T10/08-146r1

Proposed Changes to Receiver Device Physical Testing Section in SAS 2 Draft Specification

Mike Jenkins
11 March 2008

Table 72 — Stressed receiver sensitivity test characteristics

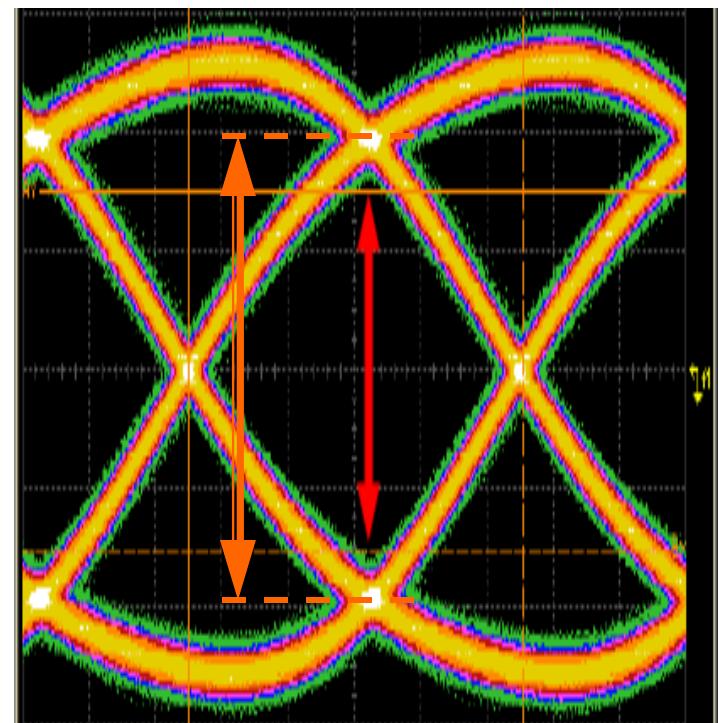
- Value in draft is impossibly small
 - 0.00022 UI is possibly the result of unintentional Excel percent formatting
- Value in 8G Fibre Channel is 0.035 UI (~20% of TX DJ budget)
- Propose 0.10 UI for 6G SAS
 - Accommodates Tx BUJ plus SSC residue

- More repeatable to measure to center of trace
 - Use vertical histogram
- For 800mVpp, 2dB launch, simulation yields $Z_1 = 101\text{mV}$

- Change Ref Tx (Table 65) & Tx peak-to-peak voltage (Table 72) to 850 mVpp
- Change Tx bounded uncorrelated jitter (Table 72) to 0.10 UI
- Change D24.3 delivered eye opening (Z_1) (Table 72) to 100mV (min) & 115mV (max)
 - Measured at center of trace
 - Simulated value is 107mV for 850mVpp launch with 2 dB de-emphasis

- Change DJ in Table 65 to BUJ with a value of 0.10 UI
- Change value for “*Minimum eye opening (i.e., $2 \times Z_1$ in figure 119)*” in Table 61 from 100mVpp to 84 mVpp
- Change value of Transmitter equalization in Table 72 from 2dB (max) to 2dB (nom) with appropriate max and min values
